# Access Compliance Report

## Public Rights-of-Way

### (Curb Ramps)

Intersection ID: 9784	Main Street: FAIRMARKET_PL	Cross Street: MONTEGO_DR	Location:	N
ADA ID: F09894BE80EE	Ramp Type: PerpDiag	Initial Pass/Fail: Fail	Overall Compliance: No	Severity Score: 13.75
Codes/Mitigation Info/Possible Solution		Field Measurements/Component Compliance

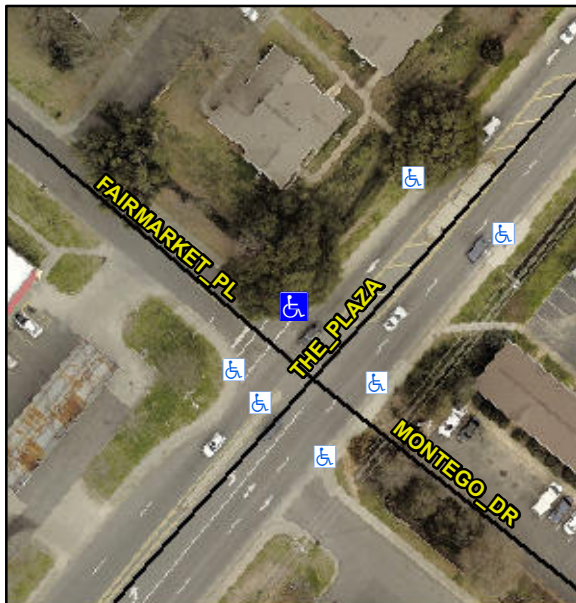
Compliance	Description	Data	Compliance	Description	Data
N/A	Ramp Length (in)	48.5	No	Ramp Slope (%)	9.5
Yes	Ramp Width (in)	48.0	No	Ramp XSlope (%)	2.6
N/A	Flare Type LT	N/A	N/A	Flare Type RT	N/A
N/A	Flare Slope LT (%)	N/A	N/A	Flare Slope RT (%)	N/A
N/A	Flare Traversable LT?	N/A	N/A	Flare Traversable RT?	N/A
N/A	Landing Length (in)	N/A	N/A	DWS Provided?	N/A
N/A	Landing Width (in)	N/A	N/A	DWS Contrast?	N/A
N/A	Landing Slope (%)	N/A	N/A	DWS Length (in)	N/A
N/A	Landing X Slope (%)	N/A	N/A	DWS Full Width?	N/A
N/A	Landing Curb? (Y/N)	N/A	N/A	DWS Offset (in)	N/A
N/A	Shared Landing?	N/A			
N/A	Gutter Ponding?	N/A	N/A	Gutter Slope (%)	N/A
N/A	Gutter Lip Ht (in)	N/A	N/A	Gutter X Slope (%)	N/A
N/A	Painted X Walk1?	Yes	N/A	Painted X Walk2?	No
	X Walk 1 Direction	To SW		X Walk 2 Direction	To SE
N/A	X Walk 1 Width (in)	109.0	N/A	X Walk 2 Width (in)	N/A
	X Walk 1 Slope (%)	0.3		X Walk 2 Slope (%)	1.8
	X Walk 1 X Slope (%)	2.3		X Walk 2 X Slope (%)	0.1

N/A	Ramp inside XWalk1?	Yes	N/A	Ramp inside XWalk2?	N/A
	Road Slope (%)	2.4	N/A	Clear Space?	N/A
	Road X Slope (%)	5.0	N/A	Clear Space to XWalk (in)	N/A
N/A	Any Obstructions?	N/A	N/A	Storm Grate/Utility Hazard?	N/A
	Obstruction Type			Storm Grate/Utility Type	
		N/A			N/A
		Yes		Surface Condition? (G/P)	Good

**Remove & Replace Curb Ramp With Two New Directional Ramps or Equivalent.**

**R304.2.2, R304.5.3**
